DOC19/987361

Revised Response to Submissions (RTS) for Viva Energy Clyde Western Area Remediation Project (SSD 9302).

Attachment A – Further Detail of EPA’s Air Assessment

Attachment B – Further Details of EPA’s Groundwater Assessment

Figure 1. Dissolved Phase Constituents with statistically increasing trends as identified in the Q4 2018 Groundwater Monitoring Report. These six trend analyses are from bores located in the south west portions of the project site.

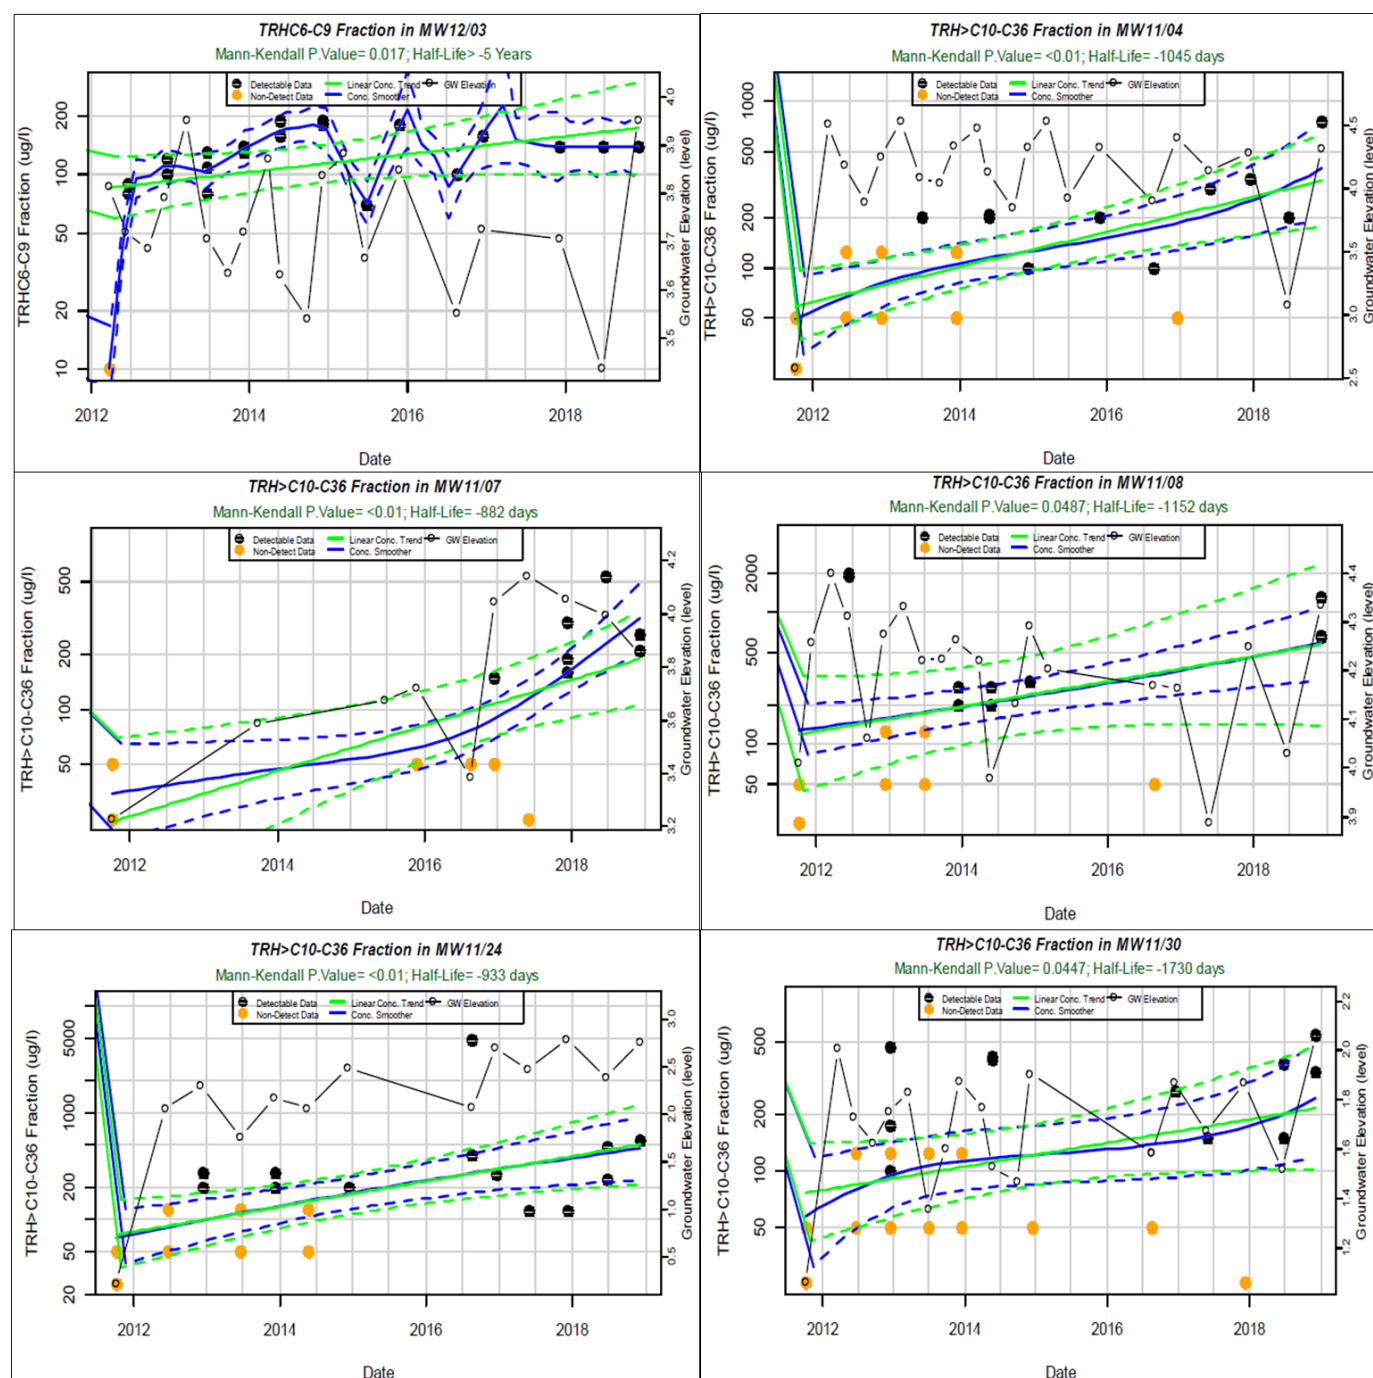
The below Mann-Kendall analyses below (figure 1) are the described exceptions to the decreasing to stable trends highlighted throughout the remediation project. These trends have been identified by the proponent, but “are not considered to represent a risk to human health or offsite ecological receptors”.

Figure 2. Dissolved Phase Constituents with TRH recent increased DPC concentrations over the last year.

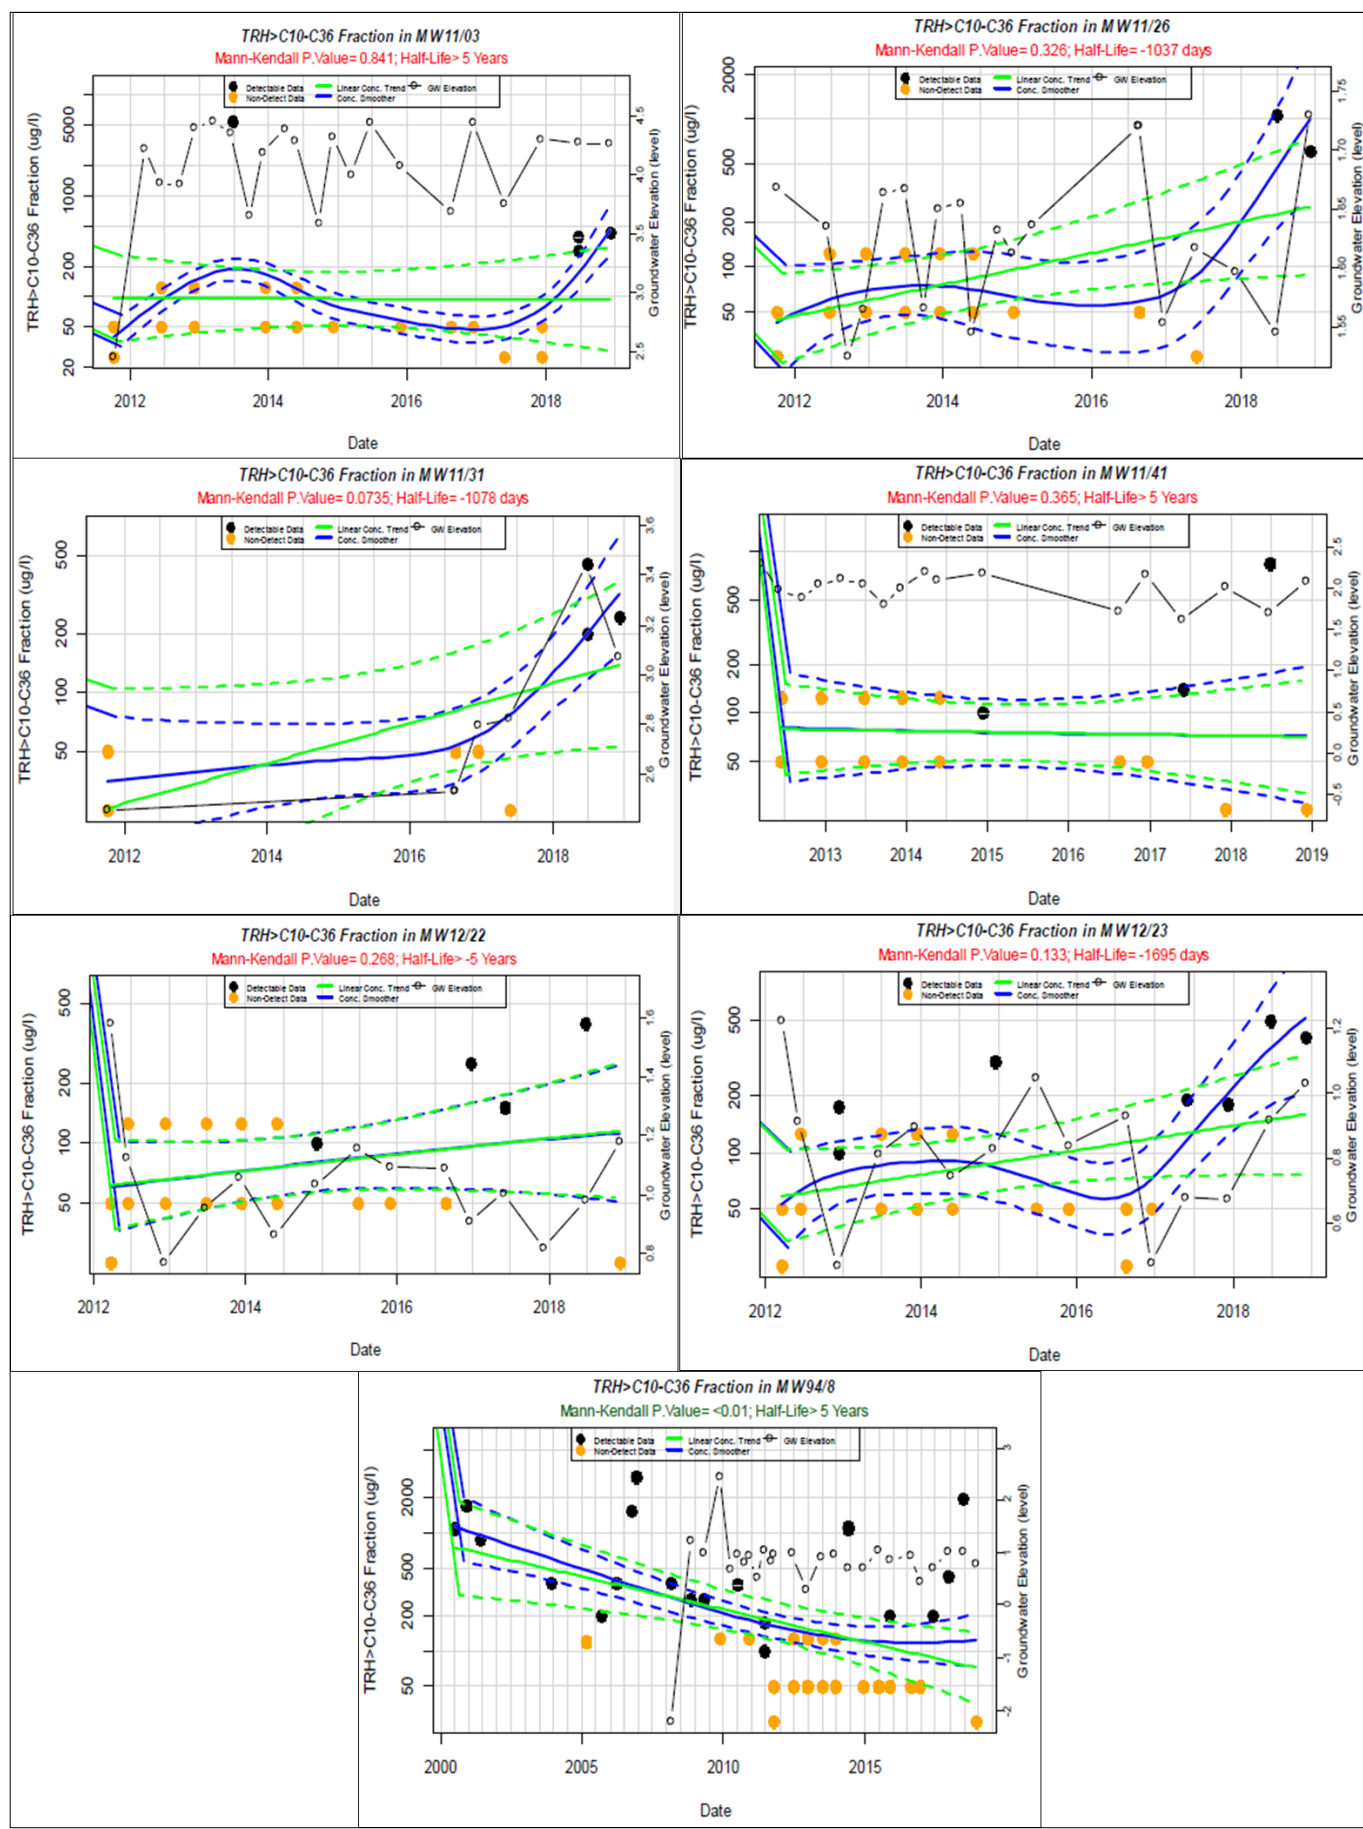
Review of all submitted Mann-Kendall trends reveal there have been recent sampling results with increasing concentrations, particularly at boundary bores adjacent to Duck River (figure 2). This indicates the possible spread of DPC’s away from the elevated concentrated area. Though impact to ecological receptors are minimal, it is worth noting that the results of trend analysis over a specific timeframe may skew based on historical sampling and analysis interpolation. Figure 3 shows the bores with a known increased concentration trend, versus bores with recent increases in DPC results.
